MEMORANDUM

From: Jesus Morales, Hydraulic Engineer, Fish Passage Engineering

Subject: Inspection of Fishways at Conowingo Hydroelectric Project (FERC #405) on May 7,

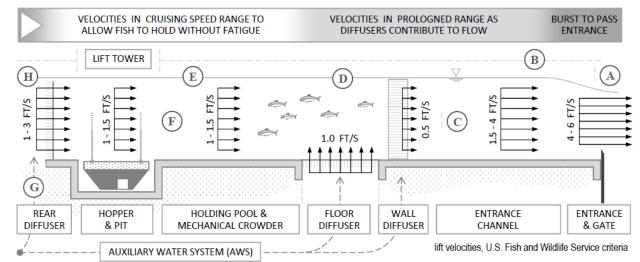
• Attraction flows - The EFL attraction water is fed through the western-most spillway bay. A significant fraction of this flow is passed down the ogee crest, through a stilling basin and into the entrance channel. The stilling basin is still not capable of dissipating enough energy to effectively allow the discharge of the original design flow (i.e., 900 cfs). The aeration and turbulence observed have been shown to dissuade shad movement. Discussions with Exelon's operators suggest that the current entrance channel design is incapable of passing more than 300 cfs without significant turbulence and aeration. Delays and ineffective passage due to insufficient attraction water are a concern.
